RISO, INC. **PARTS CHANGE INFORMATION**

PART: SHEET; TPH; A3 **ISSUE #: 037**

NEW PART NUMBER: 011-15091 NEW DESCRIPTION: SHEET; TPH; A3 OLD PART NUMBER: OLD DESCRIPTION:	[ ] New [ ] Modified [ ] Obsolete [X] Other
Compatible: [X] Not Compatible: [ ] Old/Obsolete: [N]

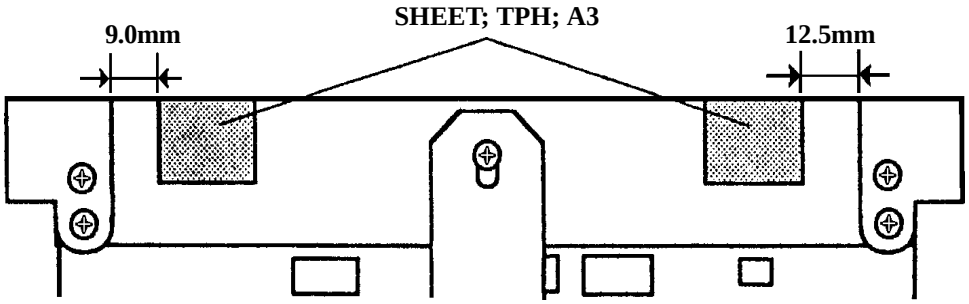
To improve machine performance and master making quality, two Anti-Vibration Sheets have been added to the Thermal Print Head. These sheets prevent vibration during master making and therefore improve master making quality.
